DWG.No. DREV-60-01

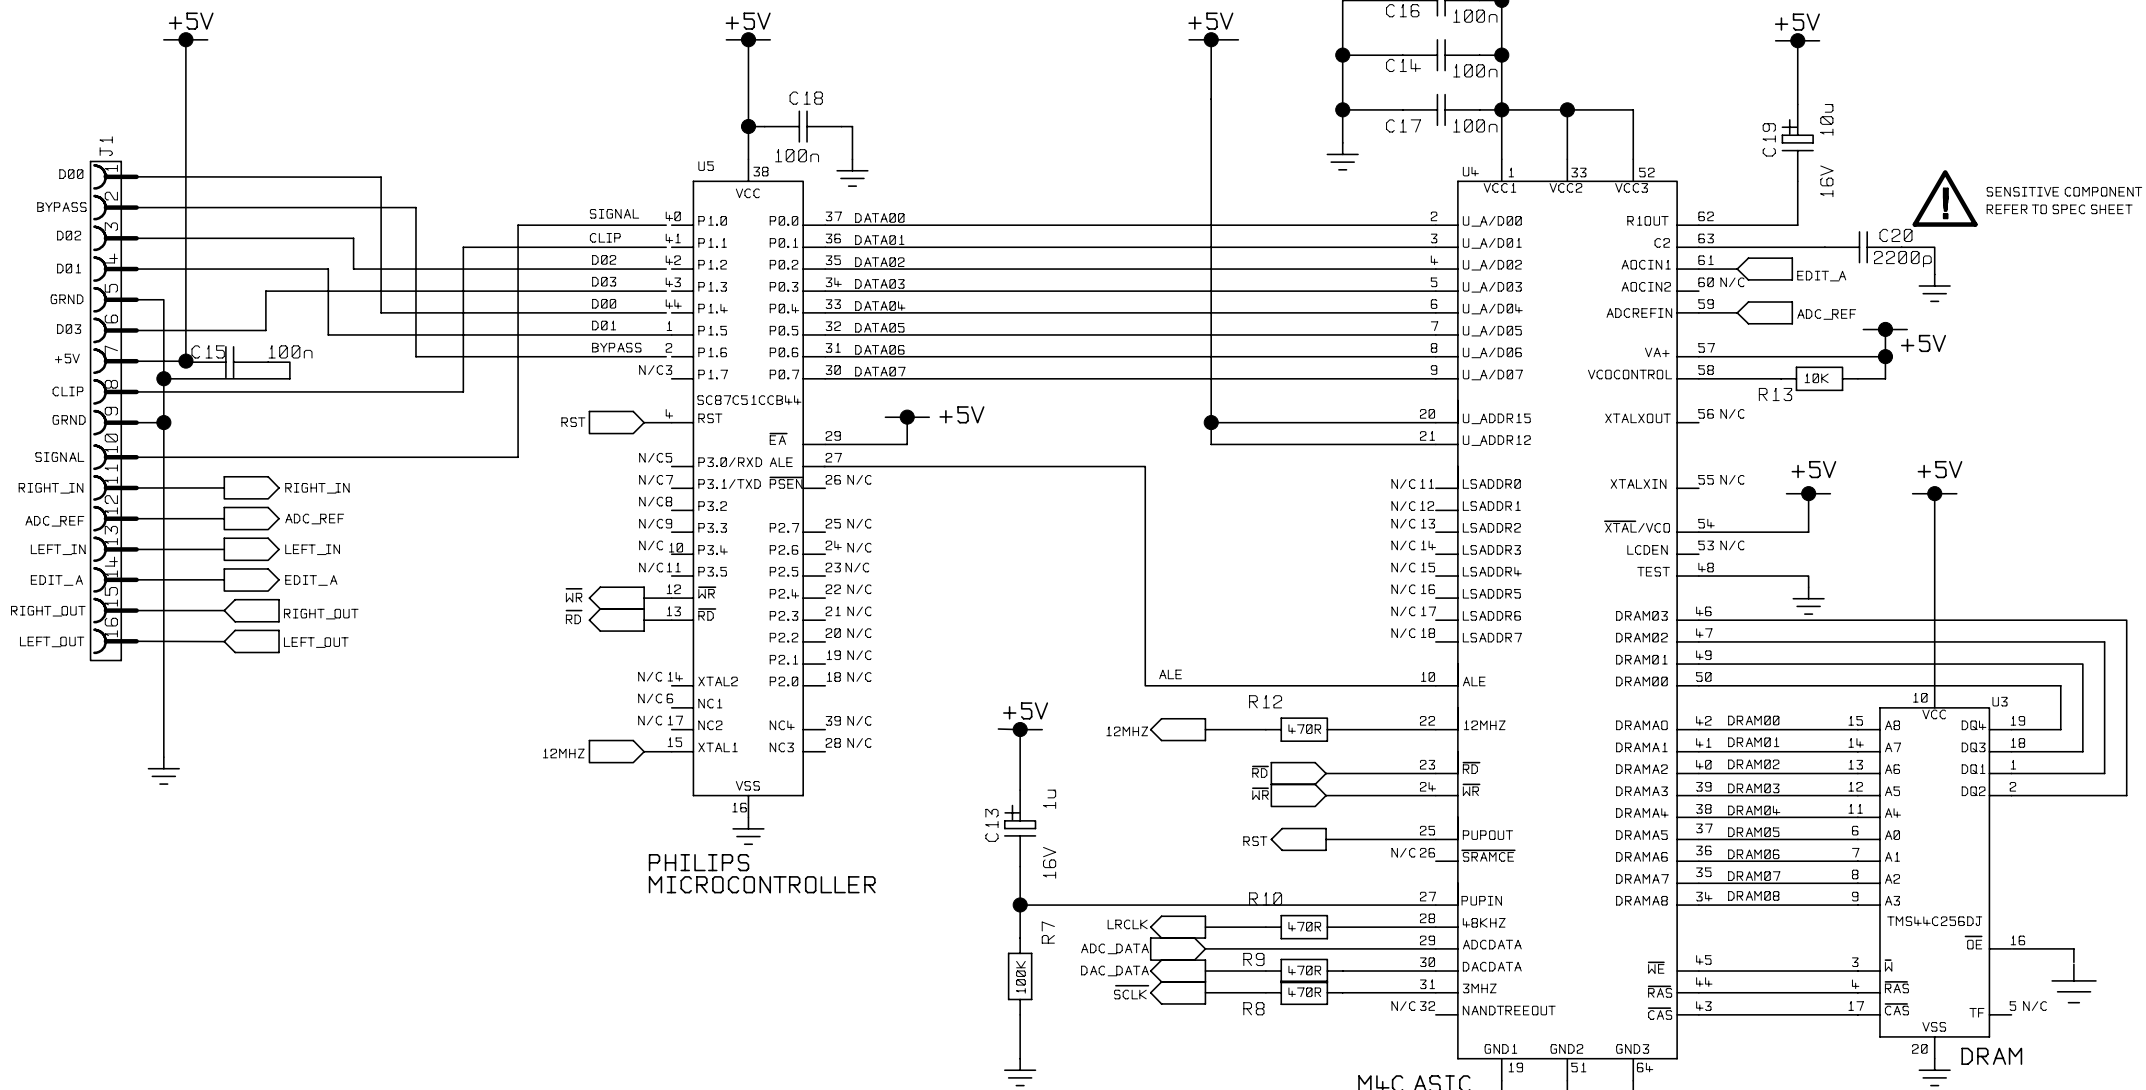
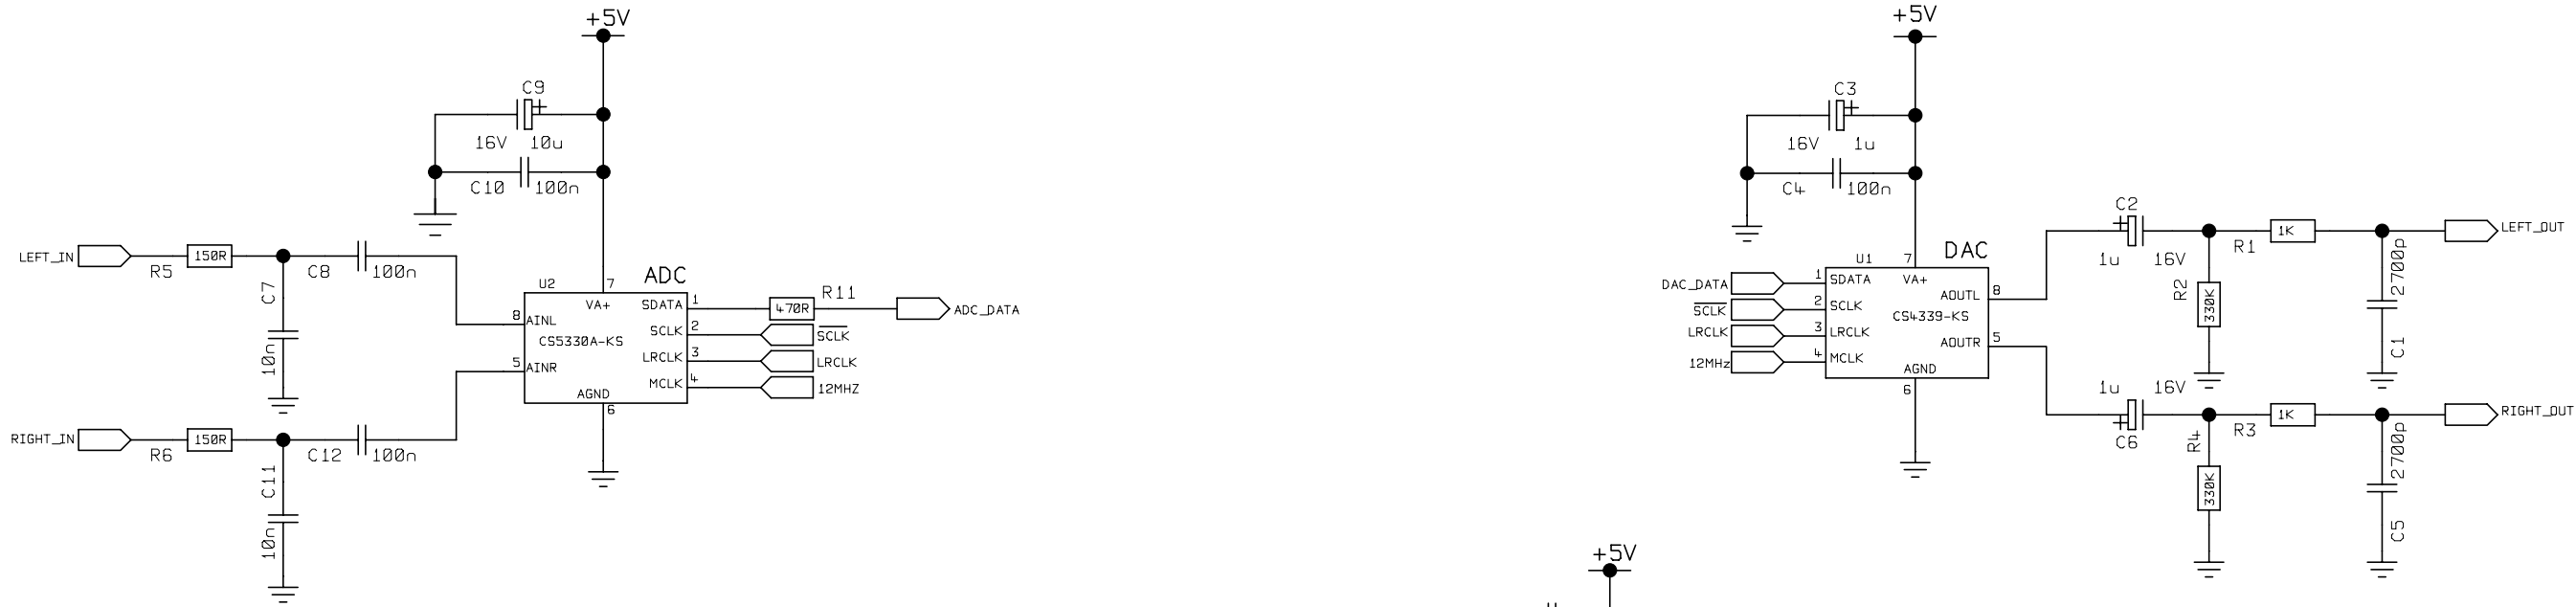
NOTE 1
ISS 2 MODS:- C2, C3, C6, C13 VALUE CHANGED FROM 10u TO 1u
R7 VALUE CHANGED FROM 10K TO 100K

5	C9 & 19 10u AL, R14 NOW R13	ALL OTHER HOLES =	X = (THROUGH PLATED)	MATERIAL	DIMENSIONS IN	 © MARSHALL AMPLIFICATION PLC DENBIGH ROAD, BLETCHLEY, MILTON KEYNES, MK1 1DQ. TEL (01908) 375411 FAX (01908) 376118	TITLE DIGITAL REVERB PCB DWG.No DREV-60-01	ISS 5
4	C9 & 19 NOW 4.7u TANTALUM	23-6-99	A	MATERIAL THICKNESS	TOLERANCE (UNLESS OTHERWISE STATED)			
3	MODS FROM RADAMEC	15-1-99	B	DRAWN A.G.	DATE 24-11-98			
2	REF NOTE 1	1-12-98	C	CHECKED	DATE			
ISS	ECO NUMBER	DATE	D	APPROVED	DATE
